BAMx Comments on the 2014-15 Transmission Planning Process
Preliminary Reliability Assessment Results and PTO Request Window
Submissions

The Bay Area Municipal Transmission group (BAMx)¹ appreciates the opportunity to comment during the development of the 2014-15 Transmission Plan. The comments and questions below address the material presented at the CAISO Stakeholder meeting on September 24-25, 2014.

Pacific Gas and Electric (PG&E) Le Grand-Chowchilla-Dairyland 115 kV Loop (May 2022)

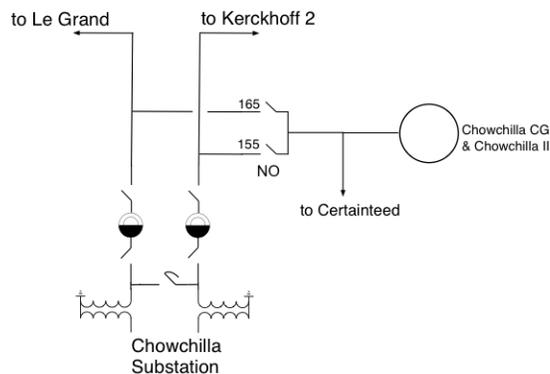
PG&E has proposed looping a relatively nearby (2 miles away) 115 kV line into Chowchilla to address near-term voltage issues and long term (beyond the planning horizon) thermal loading issues. While such a looping of an existing circuit into an existing substation would normally be a promising solution, the identified cost of \$25 million to \$40 million reduces its appeal. We suspect that most of this cost is associated with reconfiguring the current Chowchilla minimal two breaker design to a six element ring bus.

One of the issues associated with the system performance at Chowchilla is that the loss of the Le Grand-Chowchilla 115 kV line, the primary supply for the area, also results in the loss of local generation due to the system configuration. The 2024 summer peak base case models the combined Chowchilla CG and II generation at 57.4 MW. This local generation also provides substantial voltage support. The contingency for the loss of Le Grand to Chowchilla circuit also takes out Chowchilla Co Generator. We believe that closing the normally open switch 155 and opening the normally closed switch 165 solves any thermal or voltage issues identified in the PG&E's request window presentation during the September 25th Stakeholder meeting (See the figure above).⁵

⁵ An overlapping *G-I* would also need to consider the loss of the larger Chowchilla CG, but then would not need to consider the loss of Kerckhoff 2 identified in the project assessment.

The installation of four steps of 10 MVAR capacitors was identified as an alternative to address the near term voltage issues. In the event that local voltage support is needed, the cost of this element should be identified as well as whether placement is possible in a manner that does not necessitate reconfiguring Chowchilla Substation. In the event that the CAISO does approve the proposed 115 kV loop into Chowchilla, the need for the previously approved LeGrand-Chowchilla 115 kV should be revisited.⁶ The October 1, 2014, PG&E Quarterly Status Report indicates this project is still in the engineering phase.

Scenarios should be considered to explore stand-alone preferred resources or a combination of preferred resources and shunt capacitors to eliminate both voltage and thermal loading issues.
